Access Compliance Report Public Rights-of-Way (Curb Ramps)

Main Street: PROSPECT_AVE		Cross Street: FAIRHAVEN_AVE		Location:	SW
ADA ID: RPAT211021103629	Ramp Type:Type 1 - Perpendicular	Initial Pass/Fail: Fail	Overall Compliance: No	Severity Score:	15

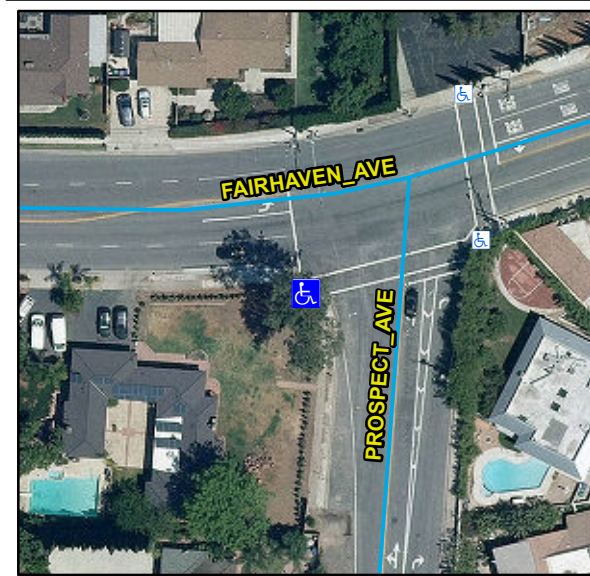
Compliance	Description	Data	Compliance	Description	Data
N/A	Ramp Length (in)	48	N/A	Flare Type LT	
Yes	Ramp Width (in)	49			N/A
No	Ramp Run Slope (%)	8.4	N/A	Flare Slope LT (%)	N/A
Yes	Ramp Cross Slope (%)	0.6	N/A	Flare Traversable LT	N/A
N/A	Landing Present	N/A	N/A	Flare Type RT	
N/A	Landing Length (in)	N/A			N/A
N/A	Landing Width (in)	N/A	N/A	Flare Slope RT (%)	N/A
N/A	Landing Run Slope (%)	N/A	N/A	Flare Traversable RT	N/A
N/A	Landing Cross Slope (%)	N/A	N/A	DWS Provided	N/A
N/A	Landing Movement Obstructed?	N/A	N/A	DWS Contrast	N/A
	Landing Movement Type	N/A	N/A	DWS Length (in)	N/A
N/A	Landing Shared	N/A	N/A	DWS Full Width	N/A
N/A	Clear Space	N/A	N/A	DWS Offset Left (in)	N/A
N/A	Clear Space To Crosswalk (in)	N/A	N/A	DWS Offset Right (in)	N/A
N/A	Marked Crosswalk 1	Yes	N/A	Marked Crosswalk 2	N/A
	Crossing 1 Direction	E		Crossing 2 Direction	N/A
	Marked Crosswalk 1 Width (in)	120		Marked Crosswalk 2 Width (in)	N/A

N/A	Ramp Inside Crosswalk 1	Yes	Yes	Ramp Inside Crosswalk 2	N/A
	Crossing 1 Slope (%)	1.9		Crossing 2 Slope (%)	N/A
	Crossing 1 Cross Slope (%)	3.3		Crossing 2 Cross Slope (%)	N/A
N/A	Gutter Ponding	N/A	No	Curb Slope	5.7
Yes	Gutter Lip Height (in)	0		Road Run Slope (%)	N/A
N/A	Gutter Run Slope (%)	N/A		Road Cross Slope (%)	N/A
N/A	Gutter Cross Slope (%)	N/A			
Yes	Overall Surface Condition: Acceptable		Yes	Perp Joint Present	Yes
	Cross Gutter Present?	No		Spandrel Present?	No
	Replace Cross Gutter?	N/A		Replace Spandrel?	N/A

Remove & Replace Entire Ramp.
